Access Compliance Report Public Rights-of-Way (Curb Ramps)

Main Street: AVENIDA_LA_PATA		Cross Street: ORTEGA_HWY		Location:	SW
ADA ID: RPRK211118144234	Ramp Type:Type 1 - Perpendicular	Initial Pass/Fail: Fail	Overall Compliance: No	Severity Score:	15
Codes/Mitigation Info/Possible Solution			Field Measurements/Component Compliance

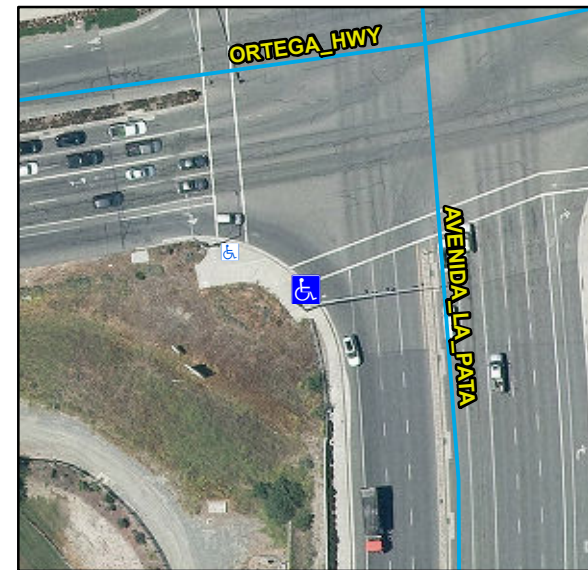
R304.2.2, STD 1115

Remove & Replace Entire Ramp.
